SERVICE BULLETIN

MODEL: CAIRE HELiOS Marathon H850

ISSUE: Vent Valve Tube Assembly

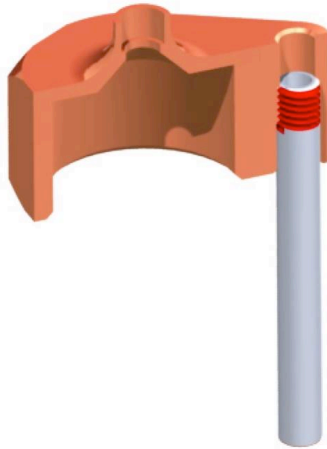
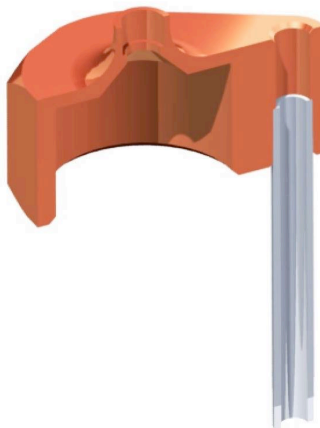
NOTES: Effective immediately, the vent valve tube will now have a threaded connection to the QDV adapter as part of rolling changes to the HELiOS Marathon H850. This is a design improvement to the previous pressed-in connection that will make a more secure connection between the vent valve tube and the adapter. This is not a field replaceable component. This change will not affect the performance of the unit in any way.

The new part number for this assembly is: 20660433
